R44

SERVICE BULLETIN SB-63

SUBJECT: Pedal Support Safety Tabs

ROTORCRAFT AFFECTED: R44 Helicopters S/N 0001 thru 1200 with more than 2200 hours total time in service.

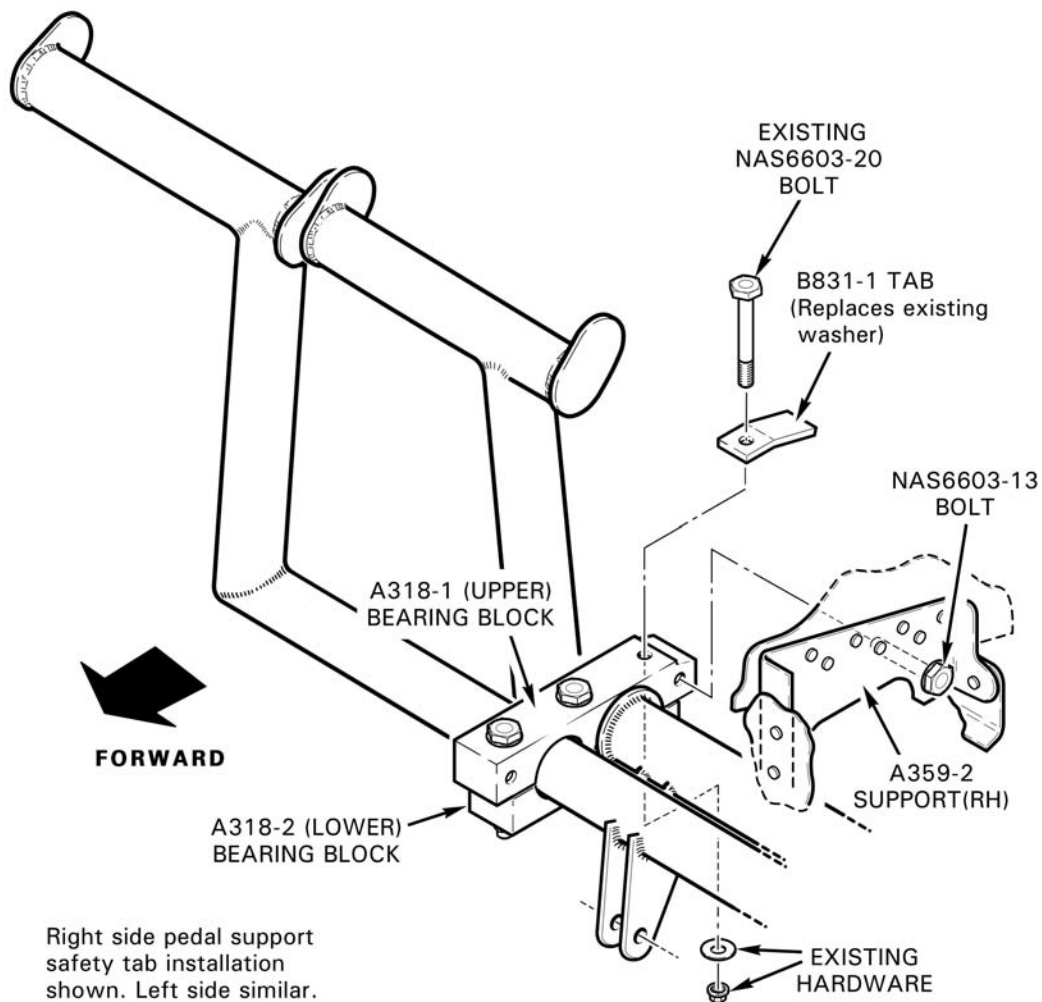
BACKGROUND: RHC has received reports of early-revision 0.040-inch thick A359-1 & -2 pedal bearing block supports cracking on aircraft with more than 7000 hours time in service. Later-revision supports are thicker. If helicopter has more than 2200 hours time in service and 0.040-inch thick supports are installed, this Service Bulletin requires installing safety tabs to prevent possible tail rotor control binding if a support fails.

1. Refer to figure on page 2. Open instrument console to access left A359-1 and right A359-2 supports. Visually inspect both supports and verify no cracks. Pay particular attention to area near NAS6603-13 bolts. Replace any cracked support before further flight.

2. Measure thickness of both supports. If either support is 0.040-inch thick, proceed to step 3. If both supports are at least 0.050-inch thick, no further action is required. Close and secure instrument console.

4. Dampen carpet adhesive between left-seat and right-seat pedals with Dupont Prep-Sol (or equivalent) to facilitate removal. Gently peel back carpeting and remove covers between pedals. Remove aft-vertical NAS6603-20 bolt and corresponding hardware from left and right bearing blocks and discard one accompanying washer per side.

5. Install a B831-1 tab under head of both NAS6603-20 bolts per figure on page 2. Torque both bolts at head to 55 in.-lb and torque stripe.

6. Reinstall covers between pedals and secure carpet with B270-7 contact adhesive (3M #74, or equivalent).
7. Make appropriate maintenance record entries.
8. At next 2200-hour overhaul, replace 0.040-inch thick A359-1 and/or -2 supports with thicker version.
